Village of Arlington Heights
Plan Commission
Board Room
Arlington Heights Village Hall
33 S. Arlington Heights Road
Arlington Heights, IL 60005
June 10, 2015
7:30 PM

To: Plan Commission
Prepared By: Latika Bhide, Development Planner
Meeting Date: June 10, 2015
Date Prepared: June 4, 2015
Project Title: Northwest Metalcraft
Address: 413 S. Arlington Heights Road

Northwest Metalcraft
413 S. Arlington Heights Road
Prepared by: The Village of Arlington Heights
Department of Planning & Community Development
January 2015

3.P

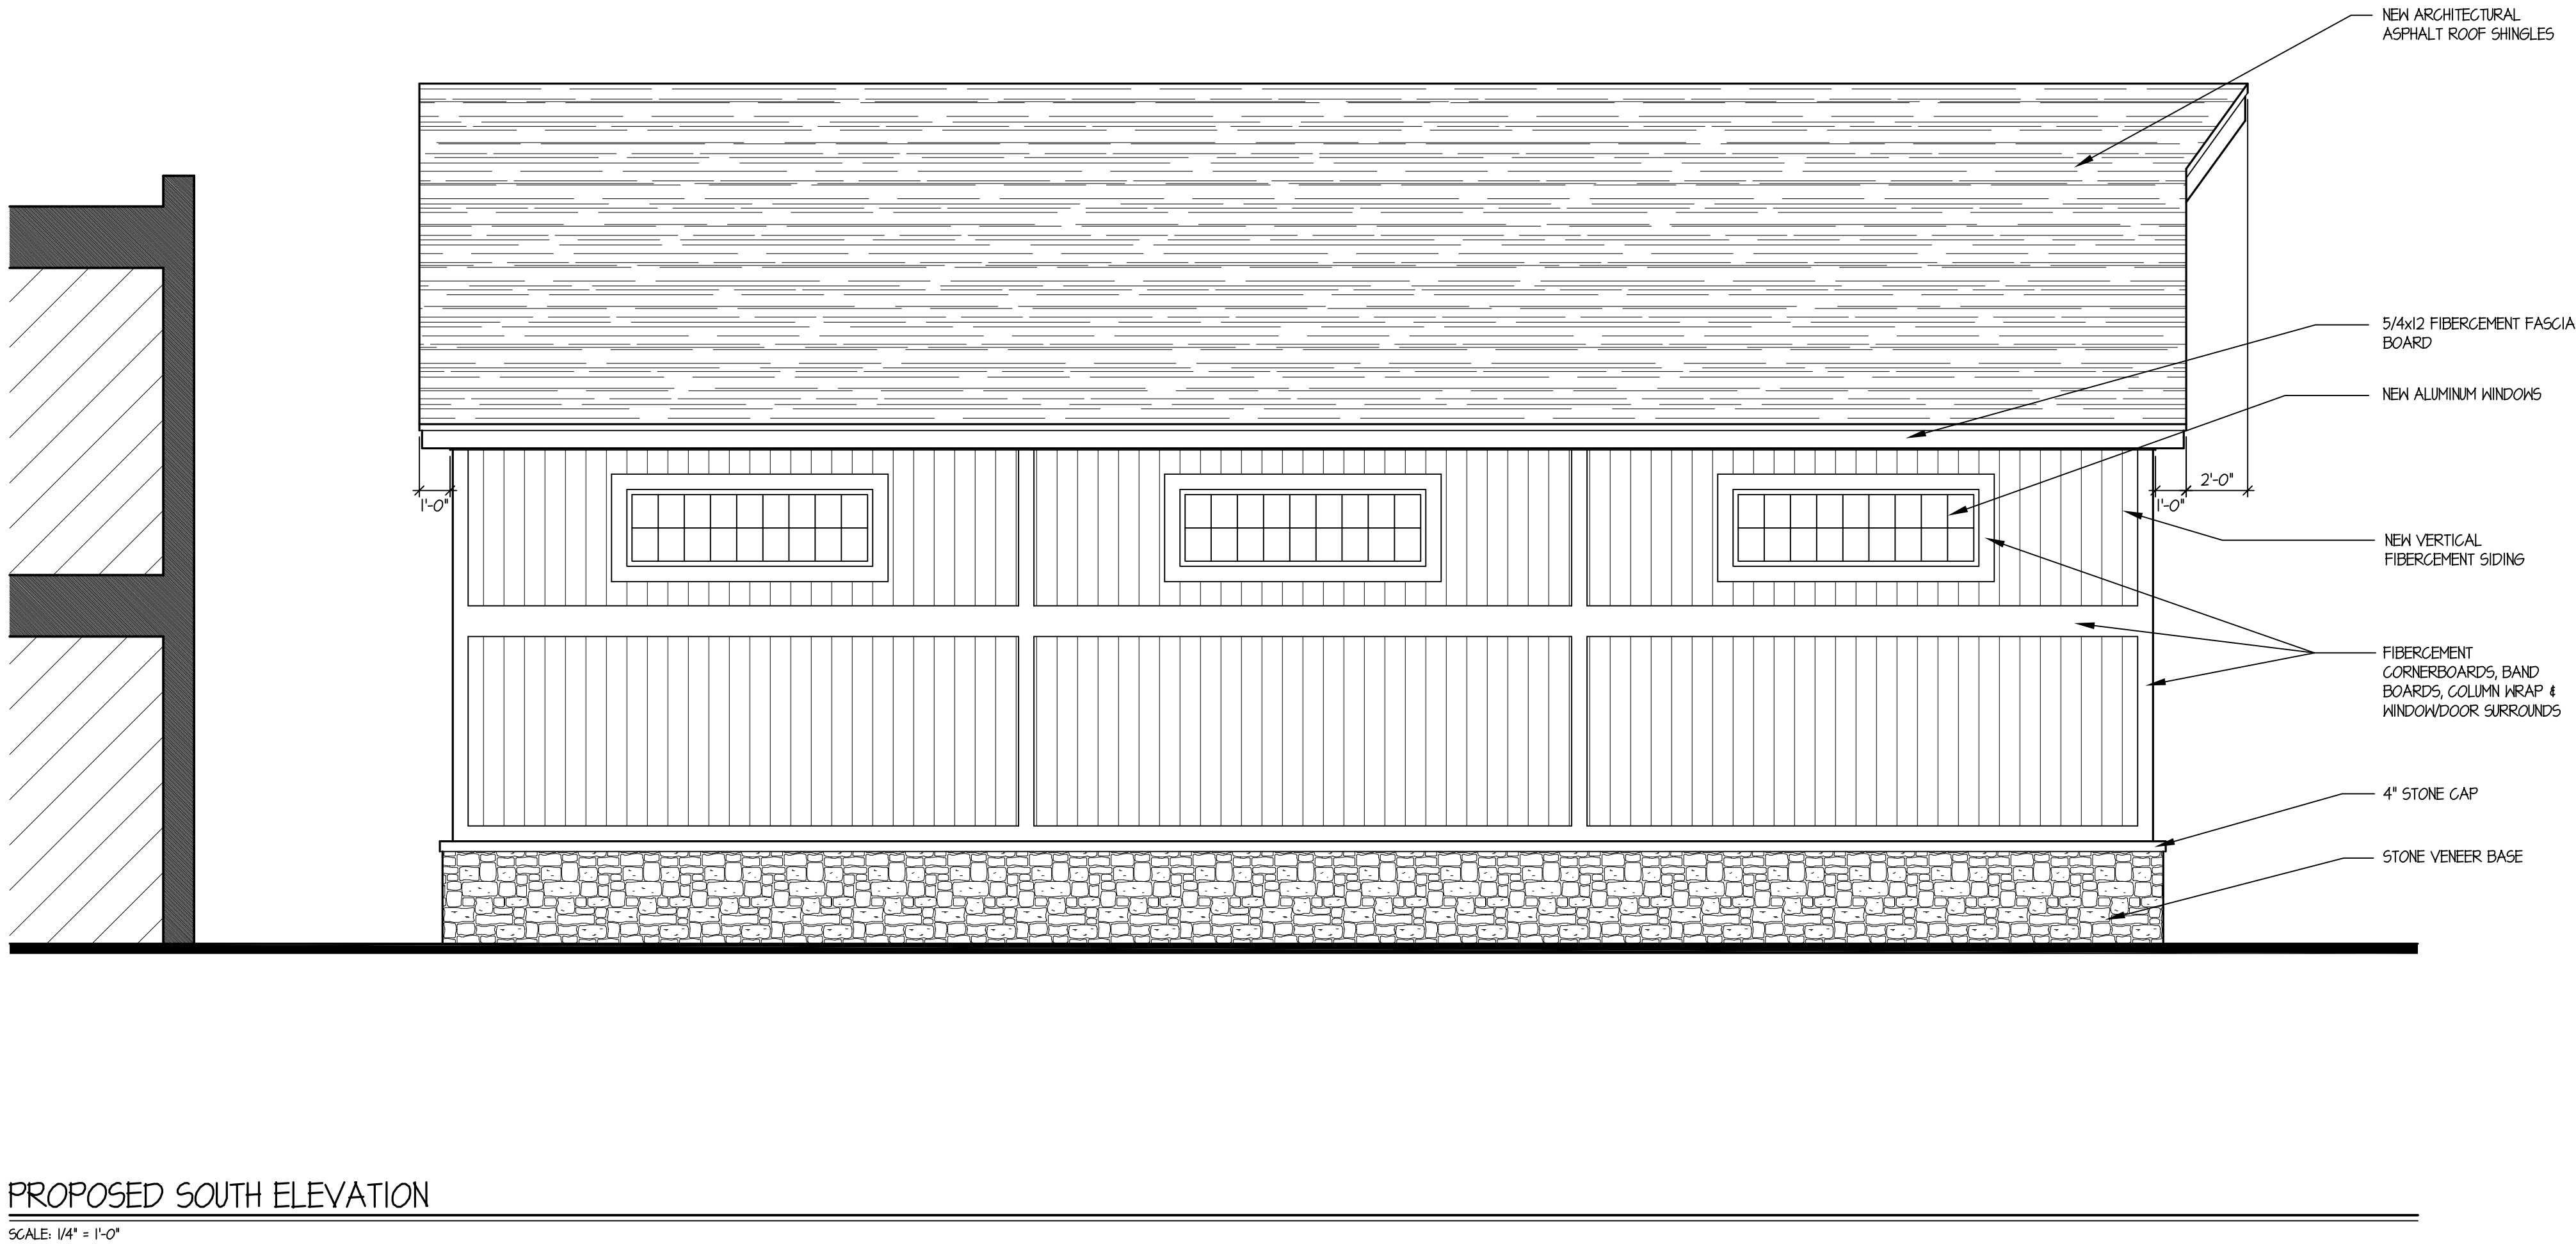
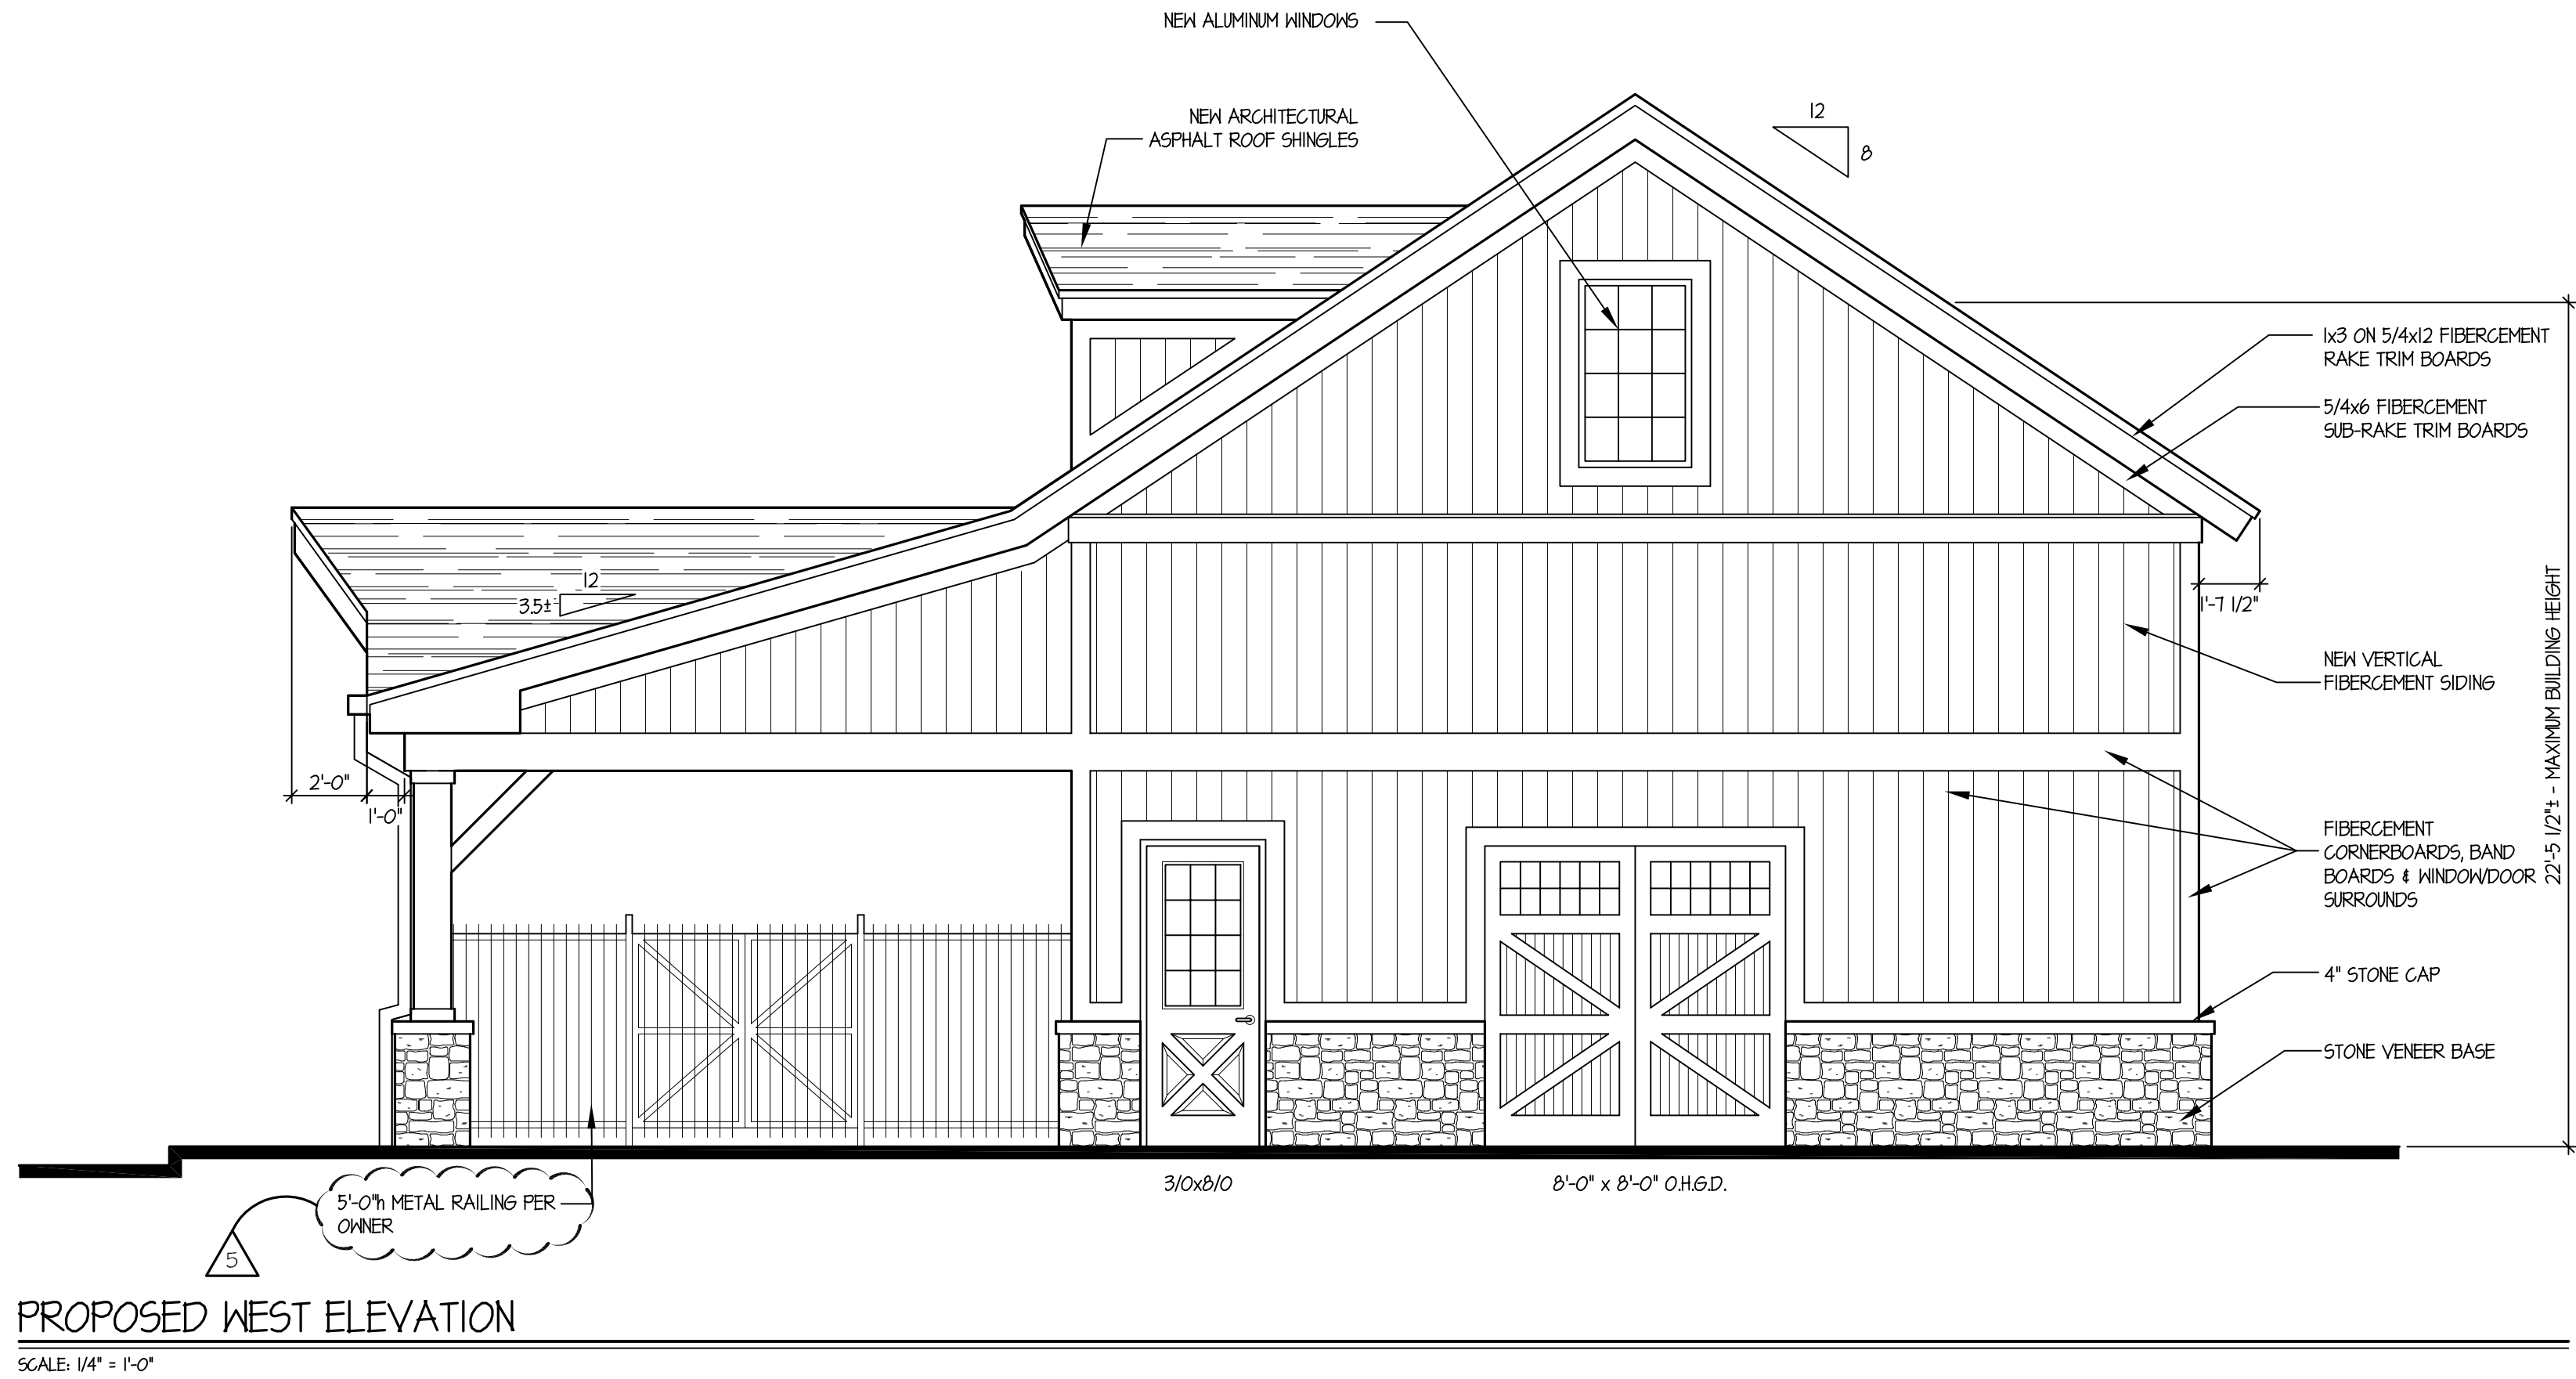
14. It appears that the fence for the outdoor display area is 6 feet tall. Fences cannot exceed...
The height of the outdoor display fence was not indicated on the plans. The plan has been modified to indicate a maximum 5'-0" height per code requirements. See sheet 3.P.
